16 Breakaway Mount

Models Affected

All MST91642A and MST91642S 16 Breakaway mounts

13744

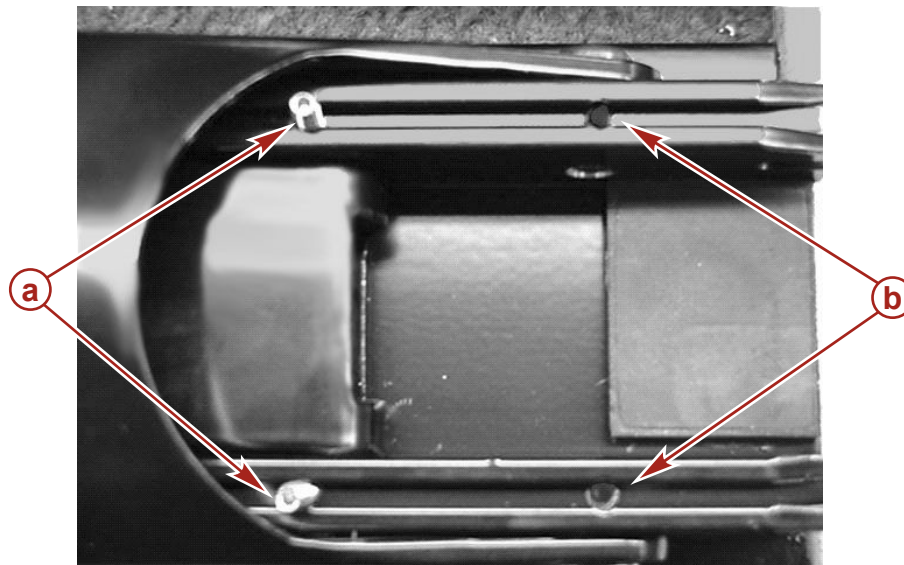
Under certain conditions, the set screws holding the bow arm and top channel to the deck channel become loose.

If you service these mounts, the set screws holding the bow arm to the deck channel and the top channel to the deck channel must be reset using Loctite® 242 Blue. The bottom two threads of the screw should be completely covered with Loctite®.

a - Set screw

b - Set screw hole
